Design Directions following Public Exhibition

Burringbar Street Concept Design

Addendum A – Swept Path Plan 60 Degree Angled Parking on Burringbar Street

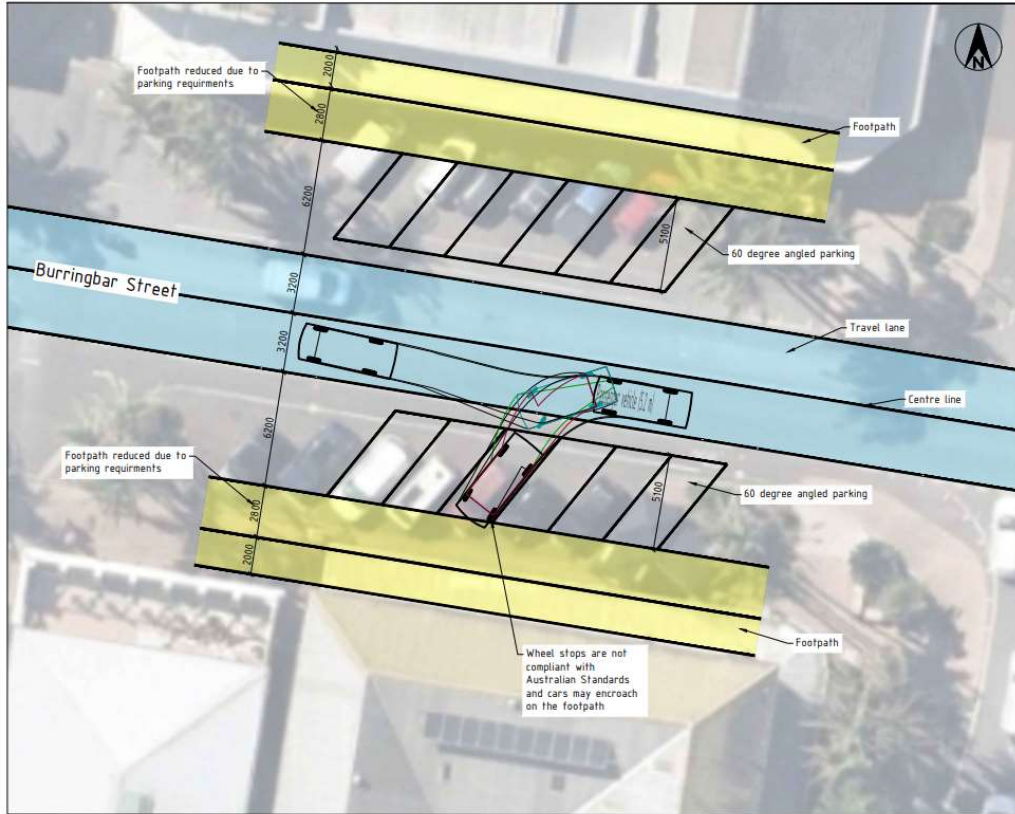
#	Topic	What We Heard	Design Recommendations
			main street, which is a key objective of the design.
5	Intersection of Dalley Street and Burringbar Street	<p>Comments such as:</p> <p>Concern about the proposed new pedestrian crossing on Dalley Street.</p> <p>Need to ensure priority at this intersection is traffic flow.</p> <p>Consider formalising or prohibiting right-hand turn into Burringbar St from Dalley St.</p>	<p>Consider option to move pedestrian crossing to Burringbar Street between Post Office and NSW Police.</p> <p>Consider best way for pedestrians to cross safely whilst supporting traffic flow along Dalley Street.</p>
6	Traffic Lanes – Direction and Widths	<p>Comments such as:</p> <p>Close Burringbar Street fully or make it one-way.</p> <p>Need to check that enough width has been provided to meet standards. From centreline to kerb 10.3m is needed at a minimum, 11.3m needed where angled parking on both sides of street.</p>	<p>Proceed with proposal of two vehicle lanes for traffic in both directions, noting that heavy vehicles still need to use Burringbar Street currently.</p> <p>Proceed with proposal of centreline to kerb distance of 9.9m. This has been guided by swept path analysis as provided as Addendum A to this document. This will be confirmed in detailed design and approvals stage.</p>

1. Concept plan based on aerial imagery and supplied dimensions. Survey required to confirm feasibility.
2. Concept Parking Layout complies with requirements stated in AS2890.5 - Table A.1
